RHODE ISLAND COLLEGE

ALGER HALL - CYBER SECURITY
RFQ25004830 – CONSTRUCTION OF CYBER SECURITY RANGE AT ALGER HALL
PROVIDENCE, RHODE ISLAND

ADDENDUM #1

November 13, 2024

Drawing Title
ELECTRICAL
ENLARGED FIRST FLOOR
DEMOLITION PLANS

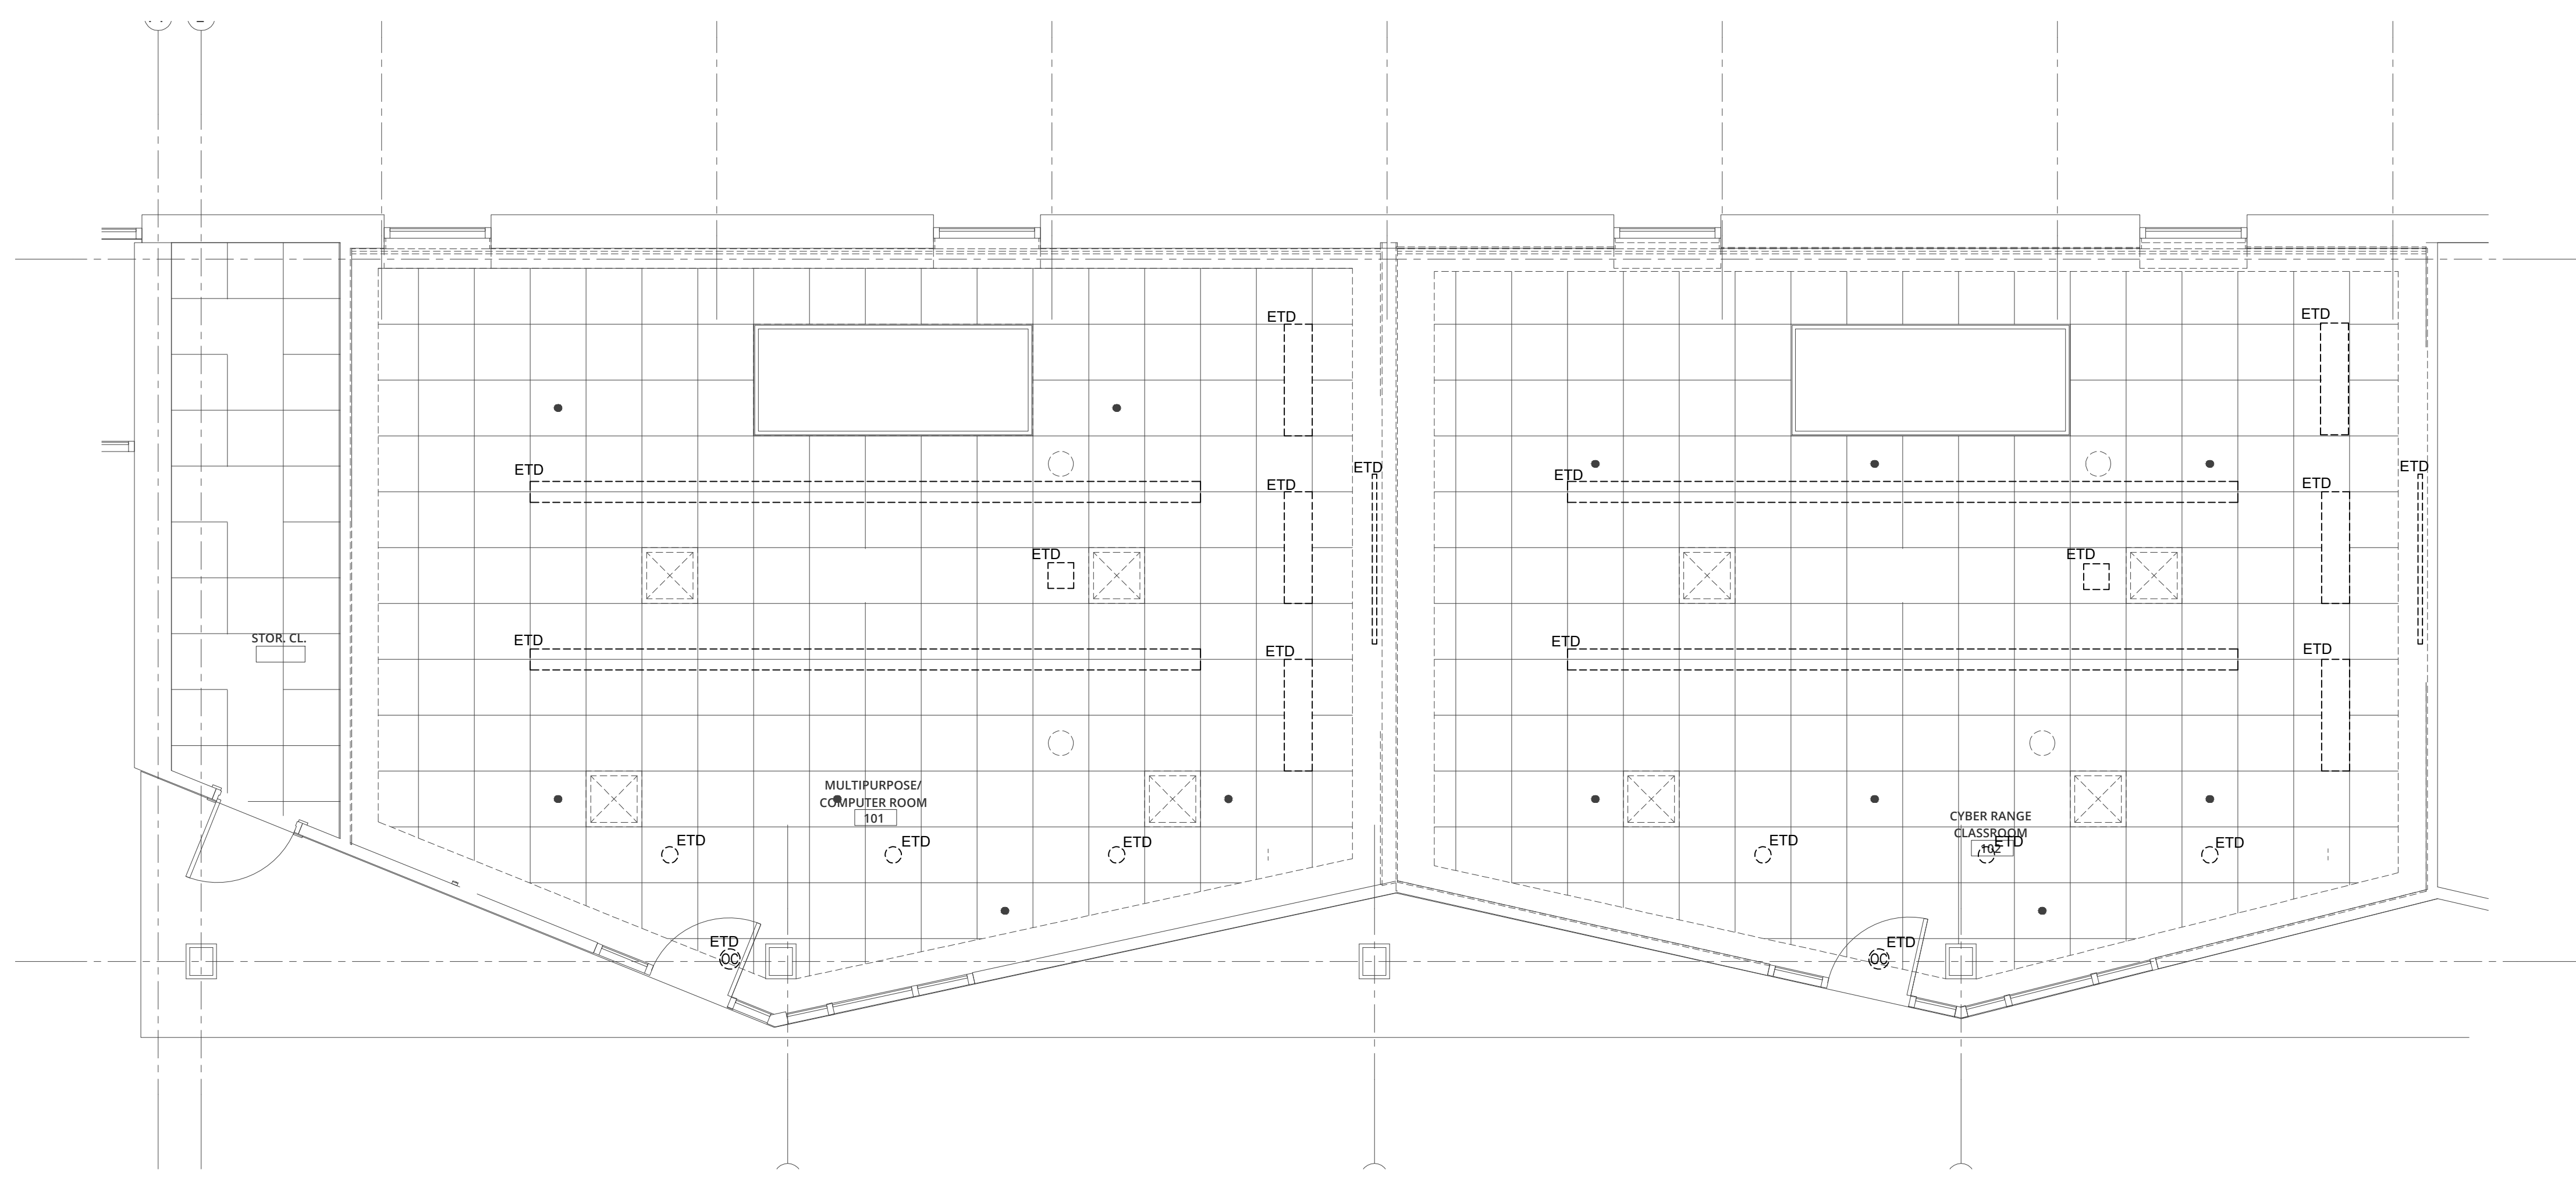
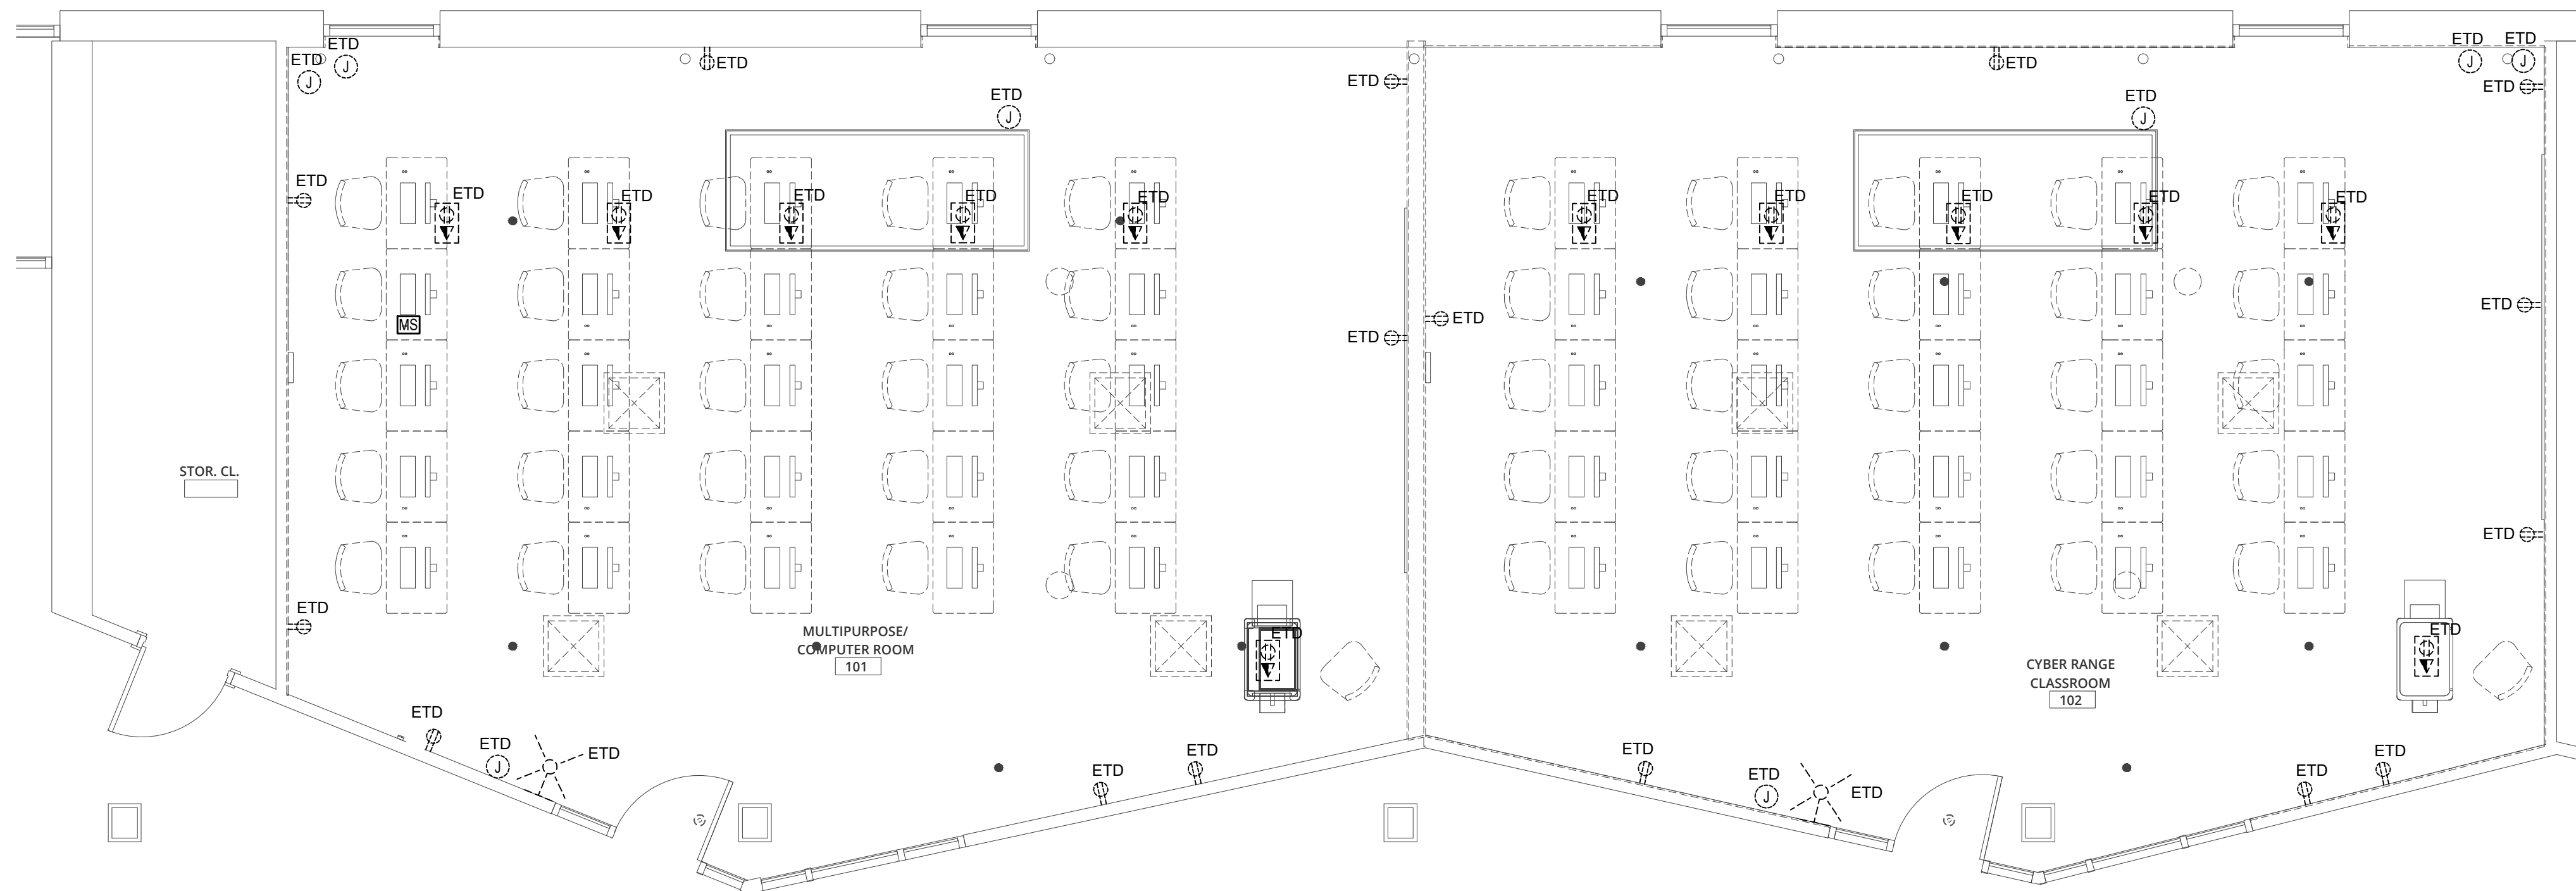
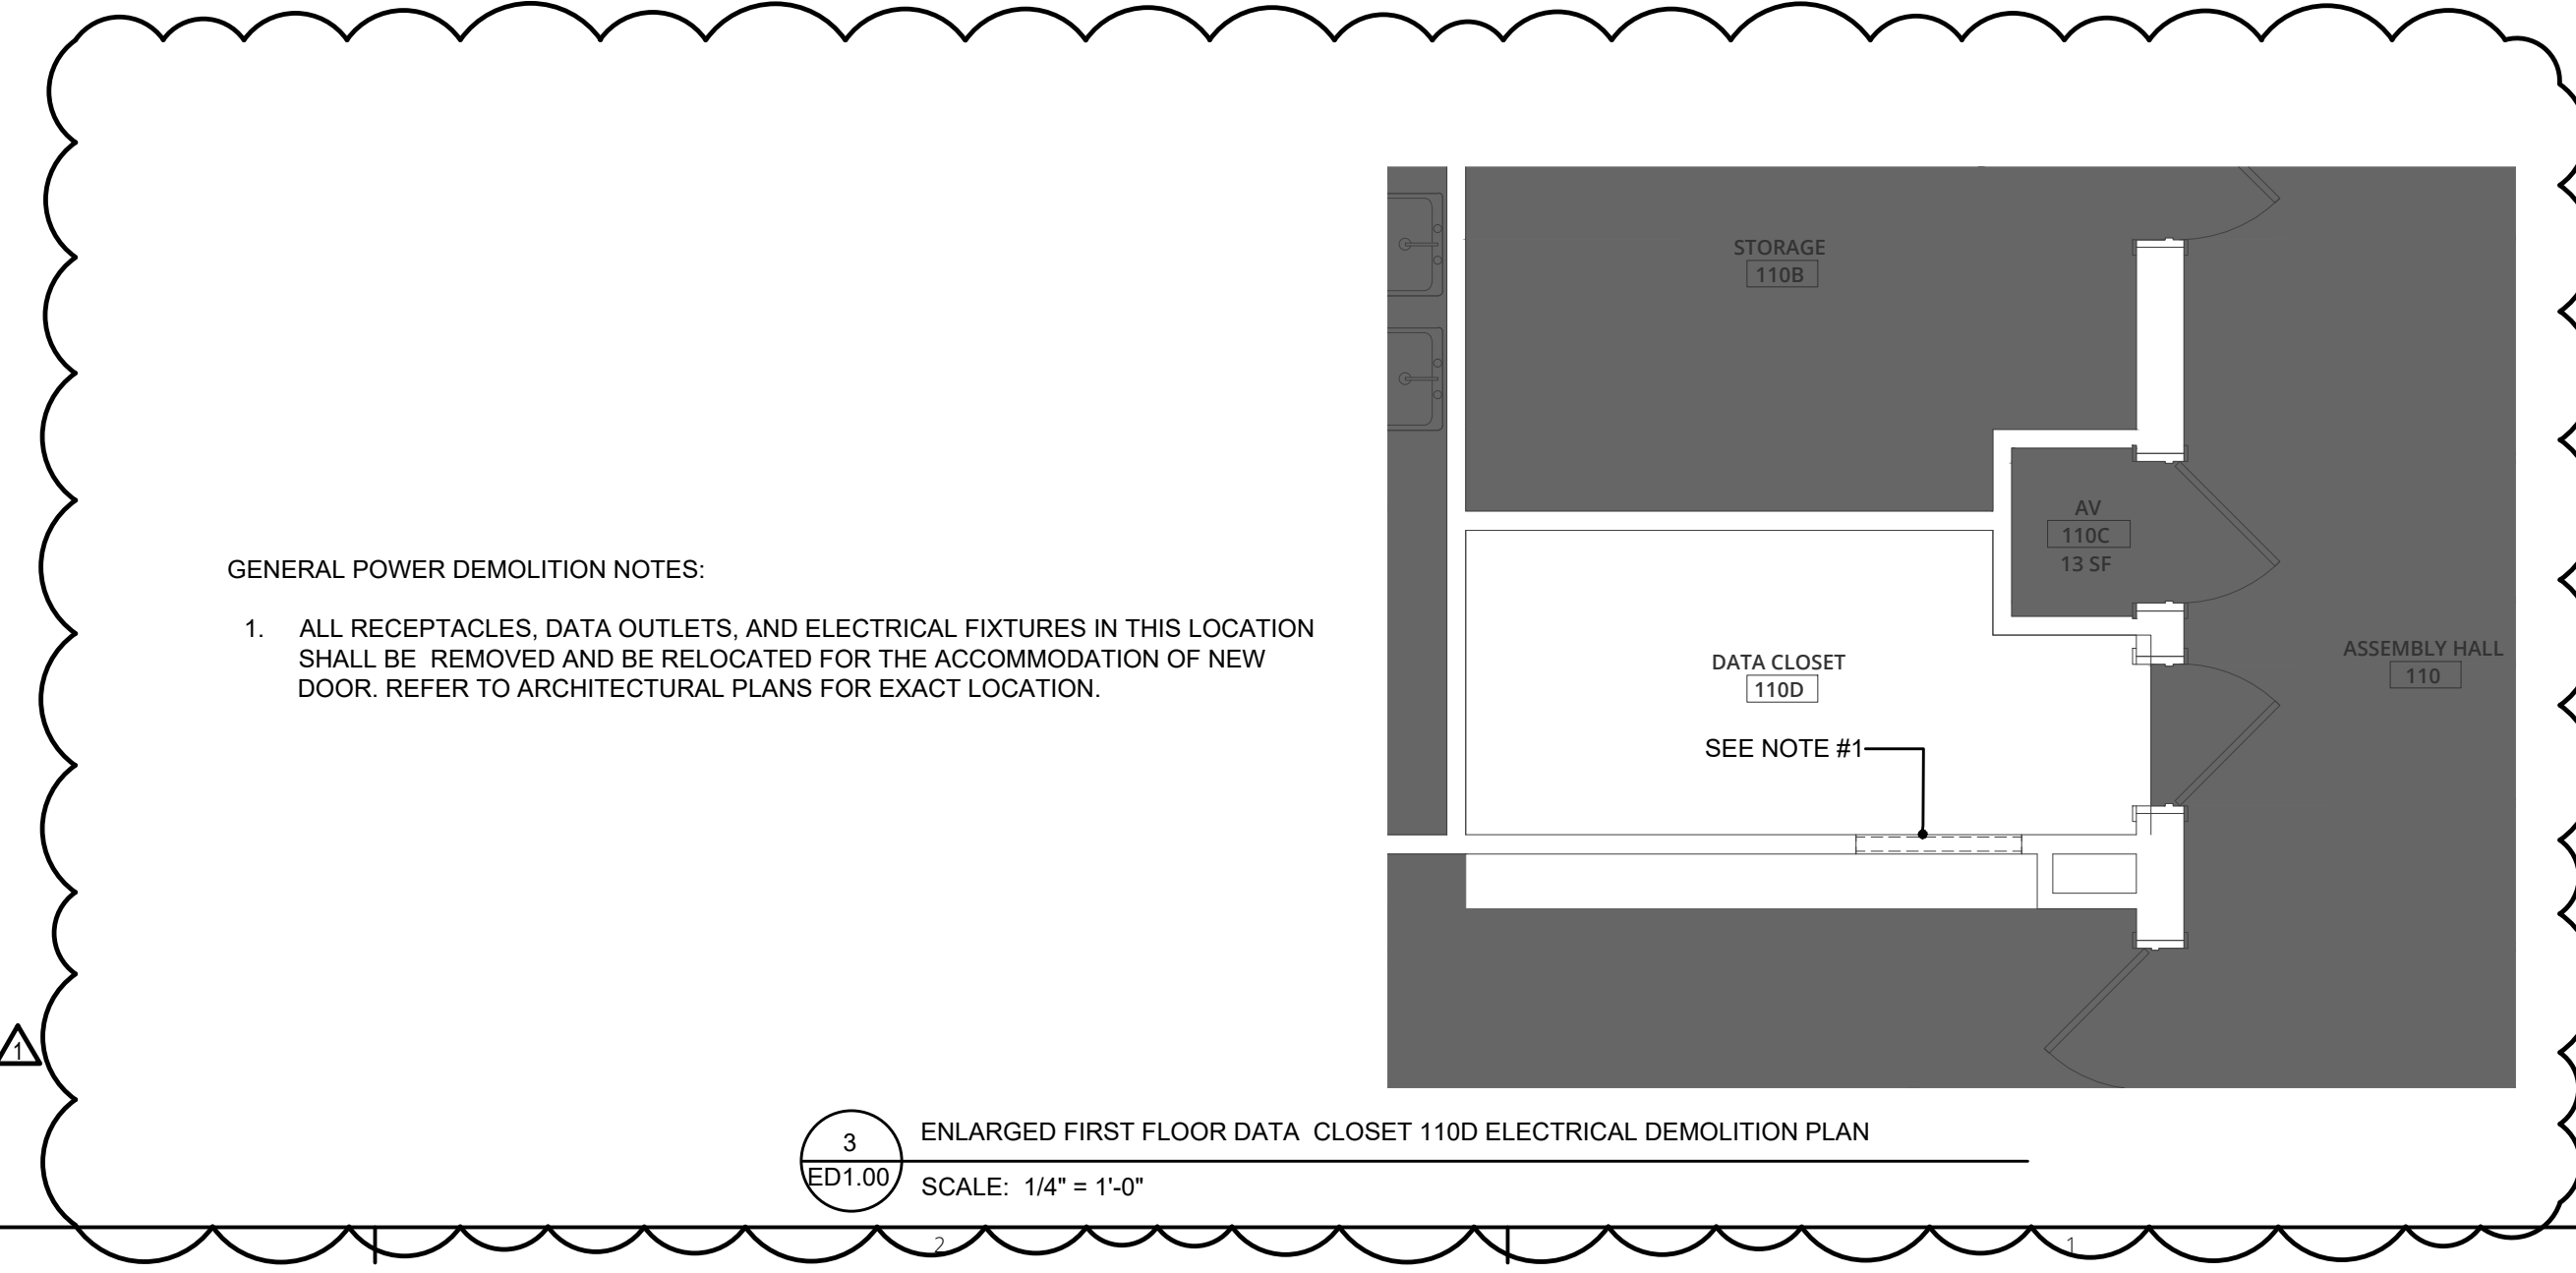
GENERAL POWER DEMOLITION NOTES:
1. ALL RECEPTACLES, DATA OUTLETS, AND ELECTRICAL FIXTURES IN THIS LOCATION SHALL BE REMOVED AND BE RELOCATED FOR THE ACCOMMODATION OF NEW DOOR. REFER TO ARCHITECTURAL PLANS FOR EXACT LOCATION.
